DEPARTMENT OF ECOLOGY

Re: Facility No. WAD120513957 Closure Plan Review

Plan Amendment and Revision of the Closure Plan
for Pesticide Disposal Drainfield at the USDA's
Yakima Agricultural Research Laboratory
September 30, 1985

MONITORING WELL DESIGN

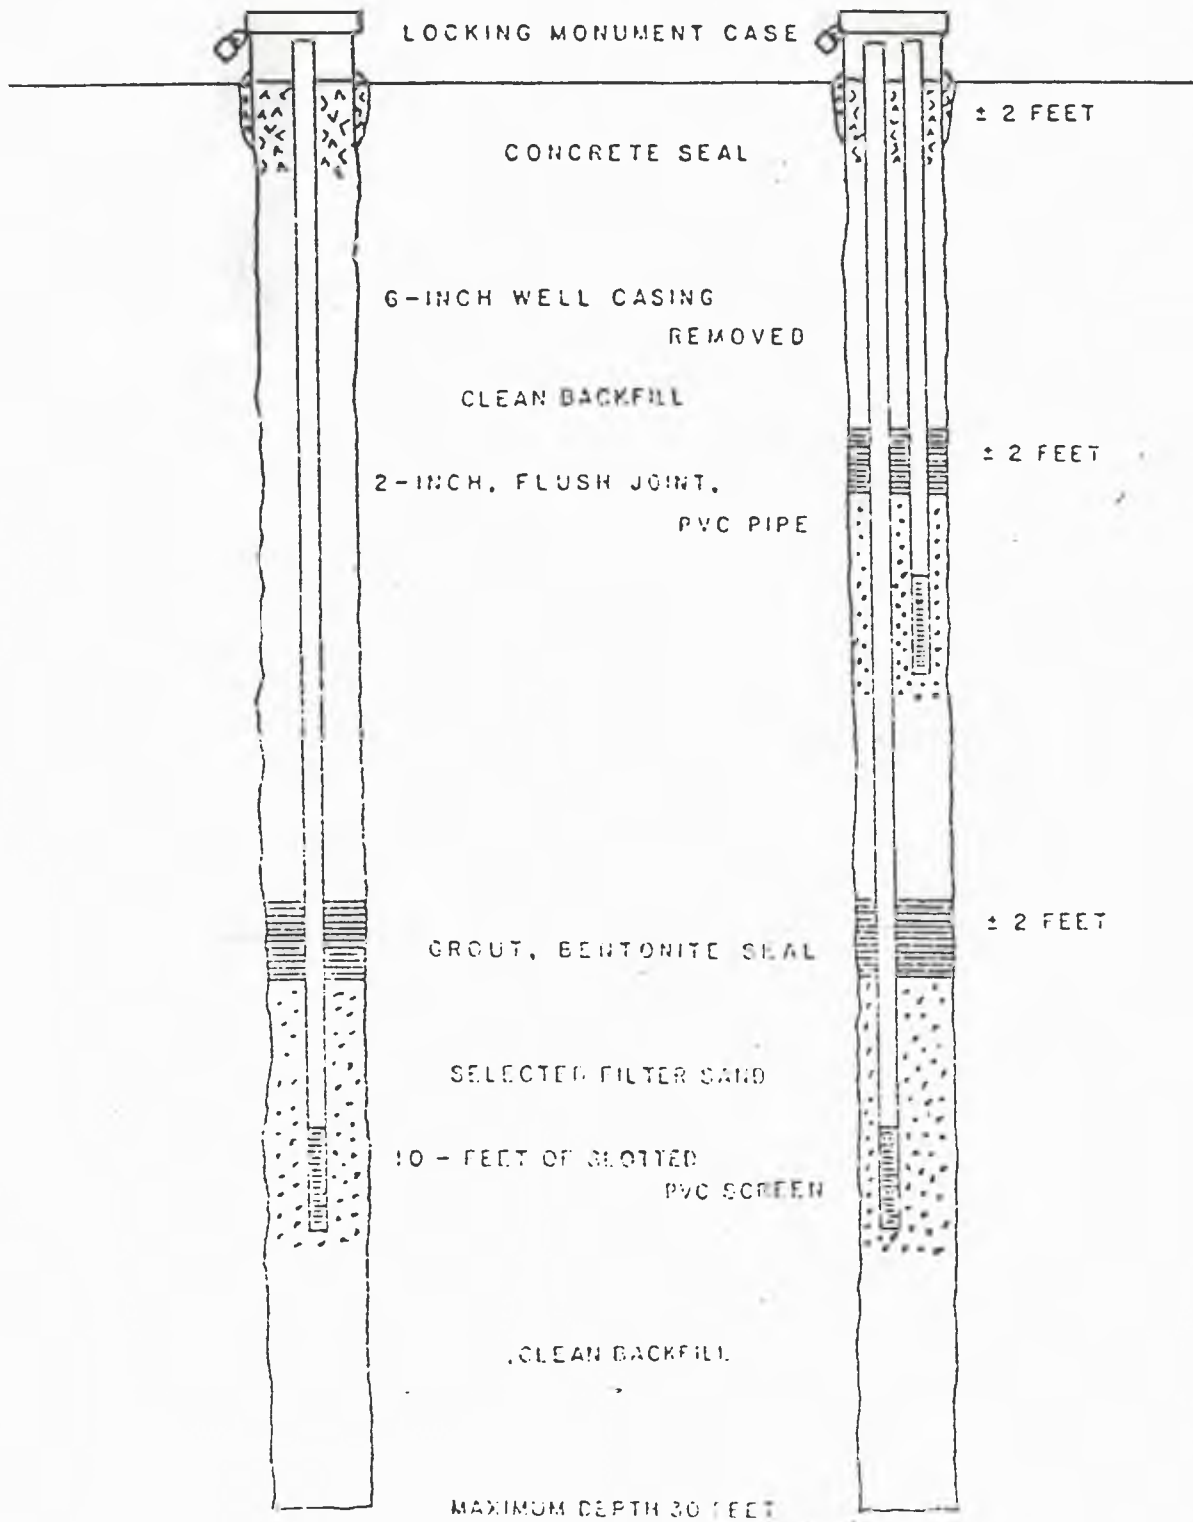
- a. At least one (1) hydraulically up-gradient monitoring well per 40 CFR 265.91(a)(1).
- b. At least three (3) hydraulically down-gradient monitoring wells per 40 CFR 265.91(a)(2) and (b)(1). The point of compliance, referenced in WAC 173-303-645(6) must be among the down-gradient points.
- c. The wells must be constructed in accordance with 40 CFR 265.91(c). All wells must be constructed so as to sample the uppermost aquifer.
- d. Proponent must develop and follow a groundwater monitoring plan per 40 CFR 265.92(a). This plan is to be submitted with the revised closure plan. The plan should include well locations, depths, screened intervals, sampling and drilling methods, and well construction. Sample collection, handling, * QA/QC and cleaning between samples is to be detailed.

Each monitoring well will be drilled using air-rotary drilling equipment equipped with a drill-through casing hammer. Six-inch diameter steel casing will be drilled to the total depth and then withdrawn during placement of the permanent piezometer(s). The permanent piezometers (monitoring wells) will be 2-inch diameter flush-threaded PVC pipe with 10 feet of slotted screen placed in the upper horizon of the uppermost aquifer. The annular space between the 6-inch diameter hole and the slotted screen piezometer pipe will be packed with selected filter sand as the 6-inch casing is extracted. The annular space above the sampling depth will be sealed with a suitable grout/bentonite slurry.

Based on existing information, the uppermost aquifer occurs at a depth of about 20 to 25 feet. Accordingly, it is anticipated that the maximum depth of the uppermost piezometers will be 30 feet or less. If ground water is encountered at shallow depths (10 feet or less) in quantities sufficient to be sampled, multiple (nested) piezometers will be set in the point of compliance borehole. If the depth of the uppermost water bearing zone is greater than 50 feet below the water table a mid-depth piezometer will be added to the point of compliance well. The depth of this zone will be determined by the well driller. Figure 3 illustrates the single and multiple piezometer completion options and construction details to be used. As shown, a grout/bentonite seal will be placed between sampling horizons in the nested completion.

Response
to the
1st
part
of
Comment
C.

After completion of piezometers in the wells, a locking monument case will be installed at ground surface as shown in Figure 3. This case will consist of a steel pipe extending approximately 2 feet above and below the ground surface with a locking, vented cover or cap. Concrete will be set within the case, extending to 2 feet depth in the annular space of the borehole. Concrete will also be set to the full case depth around the exterior of the case. The top surface of this exterior concrete will be slightly above ground surface and will slope away from the case to prevent surface water collecting around the well. Vehicular guards e.g. (steel posts) will be used to protect the wells.

Figure 4

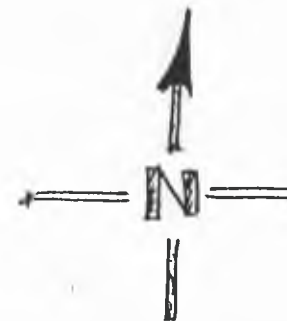
- a. Background values must be established for all Section 4.d., parameters.
- b. As mentioned in Part 1.a., and b., soil core sample locations should be shown on a map or diagram which shows their position with respect to the drainfield in three dimensions showing the site's soil and rock strata and the water table.
- c. Hydraulically down-gradient soil core sample results will be compared with the established background soil sample results to determine if there is a statistically significant increase in parameter values above background.

Soil cores will be taken at 6", 2' and 4' depths in a grid pattern that is parallel to the long axis of the drainfield tiles and extends 3' beyond the drainfield terminus. Cores will be taken at 1' and 2' on both sides of the single drainfield (Figure 4).

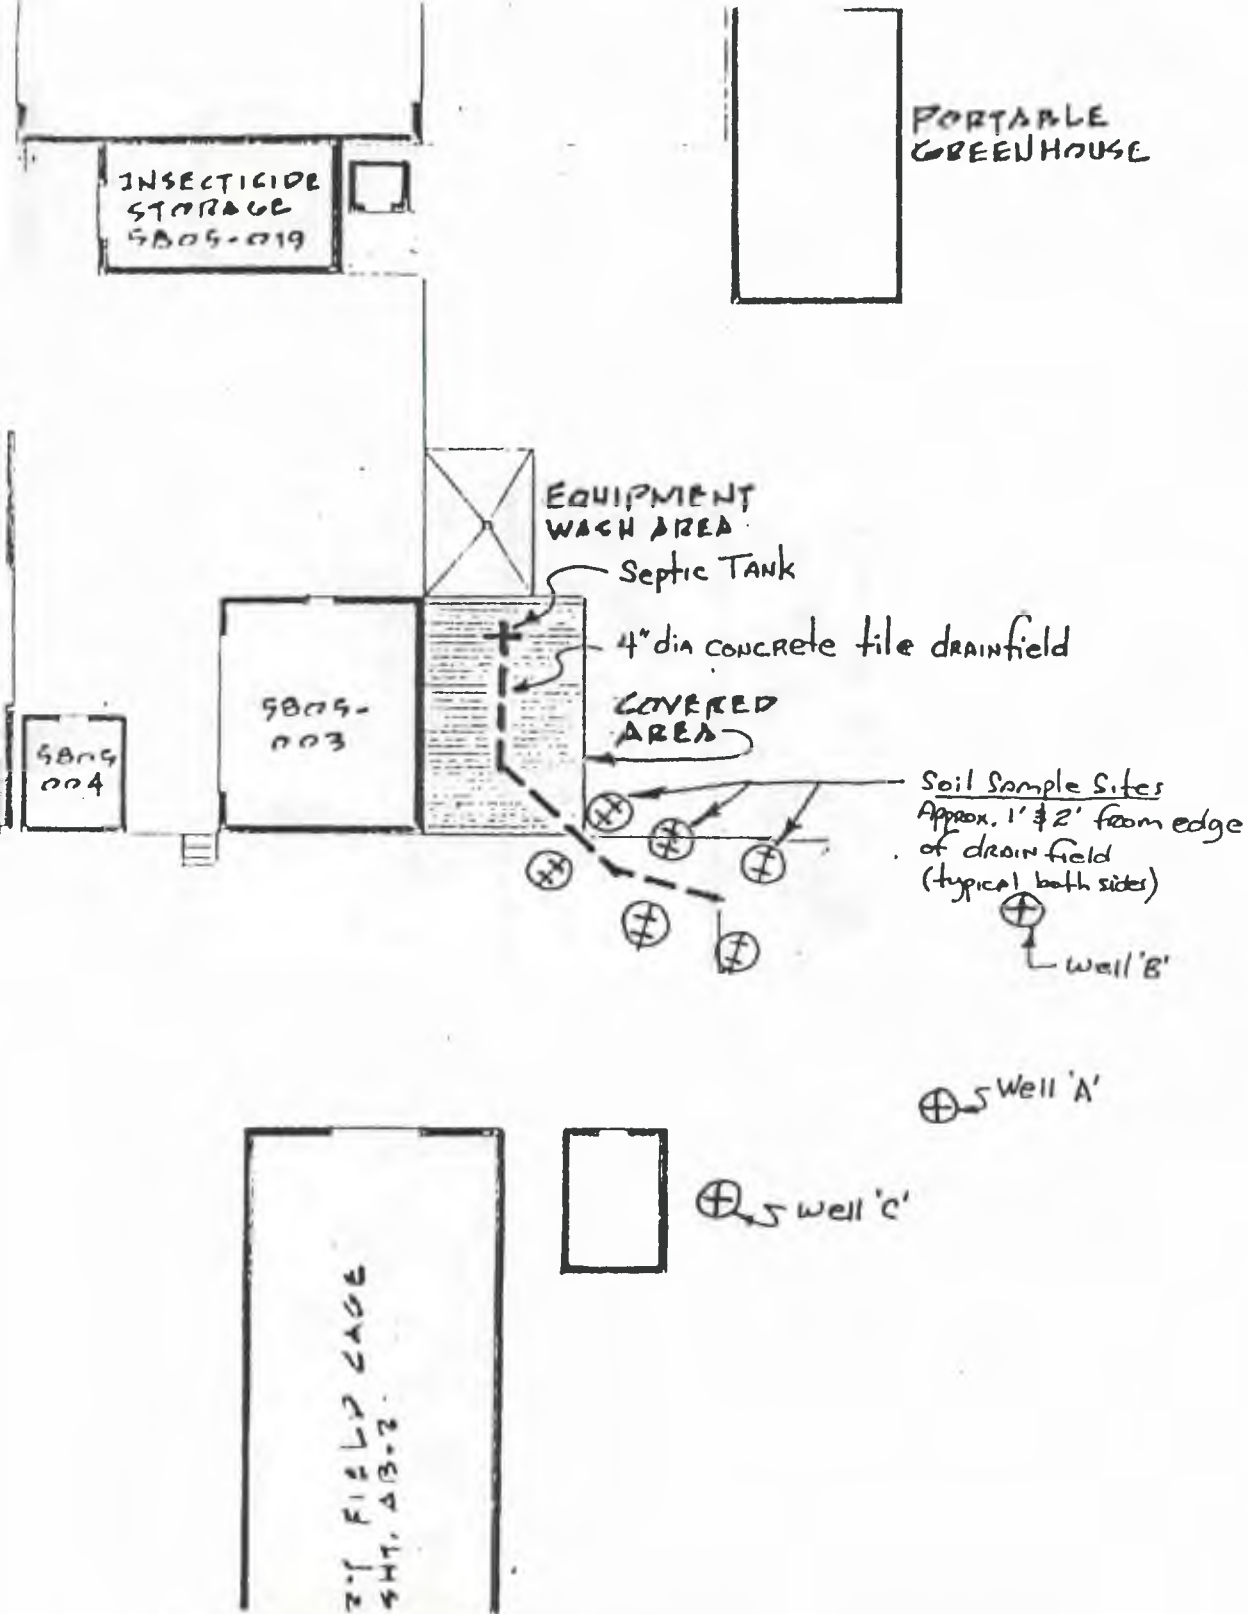
- a. A small scale map of the facility, showing the map scale, surface waters (including irrigation canals and intermittent streams), surrounding land uses (residential, commercial, agricultural, recreational), map orientation, legal boundary of the facility, injection and withdrawal wells on and off site (commercial, industrial and domestic), storm, sanitary and process sewers.
- b. A large scale map or drawing showing three-dimensional detail of the septic tank and drainfield, monitoring well and soil core sample locations.

3. MONITORING WELL LOCATIONS - To monitor actual and potential ground water contamination, YARL will have a commercial well-driller install four test wells on the grounds. Three of these will be down-gradient, toward Wide Hollow Creek (a stream located one-half mile south of the Laboratory), in the direction of groundwater flow (Reference: Department of Ecology (DOE) letter, 5/24/85, attached) (Figure 1). The placement of the point of compliance, Well A will be along a southeast transect from the system drainfield at a distance of 30 feet or less from the outside sealed drain. Well B and Well C will also be 30 feet or less from the drain along east and south transects respectively.

A fourth test well (Well D) will be placed to the north northwest on the up-gradient side, opposite of the direction of the presumed groundflow, according to the specification of 40 CFP 265.91 and WAC.173-303-645. This site is in a lawn area, west of the main building, as shown in Figure 2. The wells are to be installed by a commercial well-driller and will be used solely for water quality tests and the measurement of the depth from the surface of the ground to the top of the first aquifer.

An up-gradient soil sampling station will also be established at the well used for background evaluations. These stations are illustrated on the attached drawing (Figure 2). Shallow cores will be taken manually using a soil corer. Deeper cores including those depths that cannot be reached manually will require power driven equipment. A tractor mounted soil anger or Gitting's soil samples will be used if the target soil depth cannot be reached easily by hand tools. The soil to be sampled will be taken from the depths shown above in sufficient amounts to permit testing of the chemicals
